## ASSESSMENT REPORT

### Section 96(1A) Modification DEXUS QUARRY WEST ESTATE (SSD 6801 MOD 3)

Figure 8: Proposed Eastern Elevation of Warehouses B2 and B3

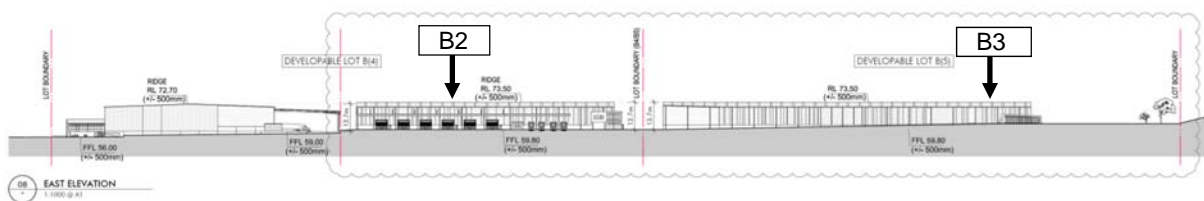
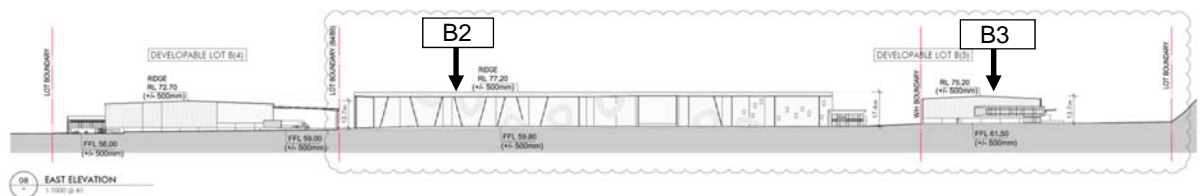
On 17 February 2017, the Applicant lodged a modification application under section 96(1A) of the EP&A Act to modify the development to amend the layout of warehouses B2 and B3 in Precinct B, located in Zone 1. The modification is described in full in the Statement of Environmental Effects (SEE) included in **Appendix B. Figure 3, Figure 4 and Table 1** below compare the approved and proposed development. Revised architectural finishes are shown in **Figure 5 and Figure 6. Figure 7 and Figure 8** compare the eastern (street) elevations of warehouses B2 and B3.

- increase the height of warehouse B2 above the 15 m height limit to 17.4 m at the ridgeline;
- introduce the storage of Class 3 Dangerous Goods (DG) in warehouse B2 (see **Table 2**);

- the proposed architectural finishes of the warehouse would mitigate the bulk and scale of the building and ensure it continues to exhibit design excellence.

**Figure 9:** Section of Proposed Warehouse B2

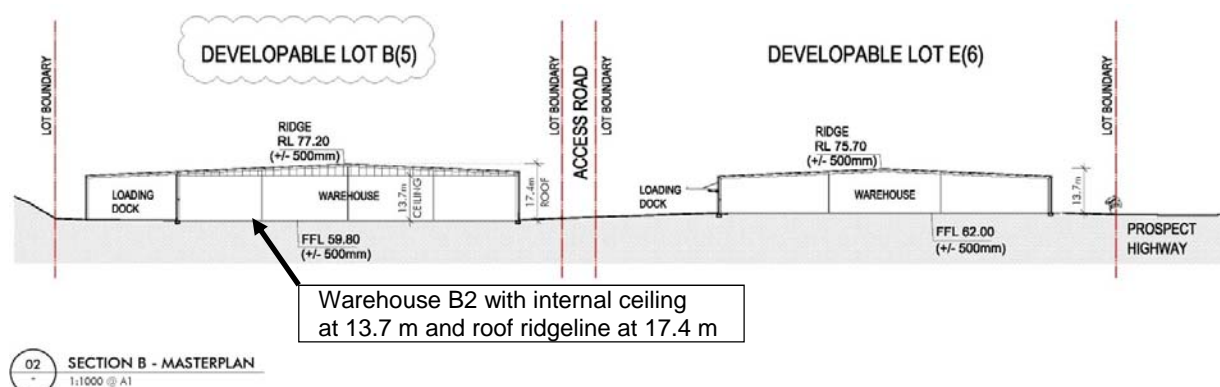
**Blacktown City Council** did not object to the modification application and requested further details of the need for the increased height of warehouse B2.

On 23 March 2017, the Applicant provided a response on the modification application, which included updated section plans and stormwater plans. The Applicant advised the increased height of warehouse B2 above the height limit under *State Environmental Planning Policy (State Significant Precincts) 2005* (SSP SEPP) is required to accommodate a partially automated, high-density storage system for pharmaceutical products. The storage system has a height of 12.7 m across the entire warehouse. To comply with fire safety requirements a ceiling with sprinklers would be suspended from the warehouse structure at 13.7 m. The warehouse design also incorporates an increased roof pitch of 2.5 degrees to mitigate the risk of potential hail damage to the warehouse. Notwithstanding, under the proposed design only structural elements and the ridgeline of the warehouse roof would exceed the 15 m height limit. The area of the warehouse above the SSP height limit would not contain pharmaceutical goods as part of the proposed operation (see **Figure 9**).

- the 2.4 m height exceedance is limited to structural roof elements (eaves and trusses) to provide an increased roof pitch to mitigate potential hail damage and facilitate the proposed high density storage system;

- the area above the 15 m height limit would not contain the proposed high-density storage system or pharmaceutical goods;
- the unique context of the site within an former quarry would ensure the exceedance in building height for warehouse B2 does not result in any adverse visual impacts on any nearby land use or residential receivers;
